Re: Florida Power & Light Company
Proposed Turkey Point Units 6 and 7
Docket Nos. 52-040 and 52-041
Voluntary Submittal to NRC Request for Additional Information Letter No. 64
(eRAI 6544) Related to SRP Section 03.05.03 - Barrier Design Procedures

Re: Florida Power & Light Company
Proposed Turkey Point Units 6 and 7
Docket Nos. 52-040 and 52-041
Voluntary Submittal to NRC Request for Additional Information Letter No. 64
(eRAI 6544) Related to SRP Section 03.05.03 - Barrier Design Procedures

SRP Section: 03.05.03 – Barrier Design Procedures

NRC RAI Number: 03.05.03-34

Figure 1 - Schematic of Impact Locations on Auxiliary Building Exterior Walls

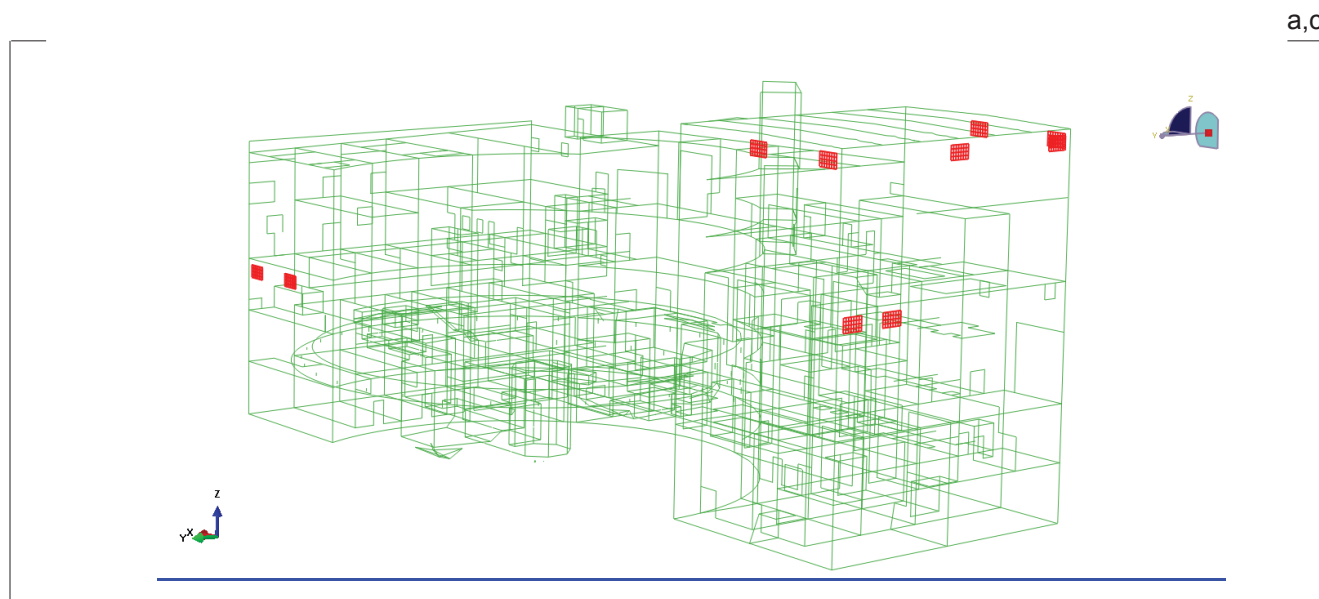
Action Item 5: Provide a justification of the use of an increase in the factor that defines the shear perimeter (0.6 instead of 0.3, where the perimeter is extended 0.6 times missile dimensions from the face of the missile). The factors of 0.3 and 0.6 are based on Reference 7. Instead of the span length the dimension of the impacting automobile area (6.6' x 4.3') was used to establish the shear perimeter. The 0.3 factor is the minimum and 0.6 is the maximum.

Five exterior Auxiliary Building walls were considered as the impacted walls. On each wall, Case 1 is referred to as the impact area close to the edge of the floor/roof and the wall to study the corner effect. Case 2 is referred to as the impact area close to the floor/roof along the middle edge of the wall to study the edge effect. The impact locations on each wall are shown in Figure 1.

Similar to interior impact, one-way shear does not govern in edge and corner impacts. For two-way action, the out-of-plane shear is within an allowable of $V_c = \phi 4 \sqrt{f'_c} d$, over a length of $6.6' + d$ directly above the impact. In the case of one-way shear, the allowable is $V_c = \phi 2 \sqrt{f'_c} d$ over the entire span. [Since the entire span length is much more than two times the length of $6.6' + d$, two-way action will govern].^{a,c}

The peak out-of-plane shear member forces evaluated by [time history dynamic analysis]^{a,c} for each impact case are given in Table 6. SF4 is out-of-plane shear along the vertical sides of the element and SF5 is out-of-plane shear along the horizontal sides of the element. The out-of-plane shear created by the hurricane automobile missile is evaluated using allowable stresses in accordance with ACI 349-01 that are shown in Table 4. However, it is noted that they are reduced [to reflect the removal of the DIF of 1.1 since the DLF is below 1.2].^{a,c} As shown in Table 6, [Impact Case 2 (edge case SF5) of Wall Q has the maximum peak out-of-plane shear at the edge of the impact area of the automobile missile equal to 51.42 kips/ft].^{a,c} For Impact Case 1 [(corner case SF5), the peak value is equal to 44.65 kips/ft for SF5].^{a,c} As seen from Table 6, all of the shear member forces are below the allowable.
